Bankstown Airport Birdwood Road Mixed-Use Project Major Development Plan

Supplementary Report

26-Jun-2025

Site layout, access and servicing

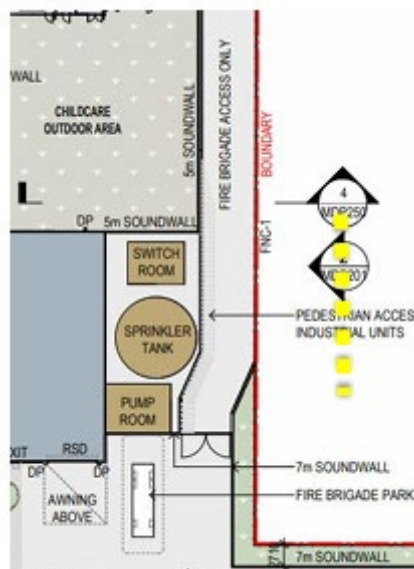
- Council is supportive of the pedestrian crossing as proposed in section 4.4 Pedestrian Access and Facilities of the Transport Impact Assessment. This needs to be indicatively shown on the architectural plans.
- Council has strategic land holdings located at 179A (being lots 231/810948 and 232/810948). We raise no objection to the proposal but would seek the following provisions as part of the development.
- The proposed soundwall needs to be extended for the area where the pump room has been sited, this should be extended up to the noise wall (yellow dotted line) associated with the outdoor play area for the proposed childcare centre, in order to protect the amenity of future dwellings that may be located on Council owned land.

- Provision of a drainage easement (connecting to the stormwater management system of the proposal to allow for the gravity stormwater drainage of future dwellings that may be located on Council owned lots 231/810948 and 232/810948).
- The proposed driveway crossing splays onto the existing driveway layback for Council owned properties. This should be widened to include driveway of Council owned lot, to create a holistic driveway crossing.
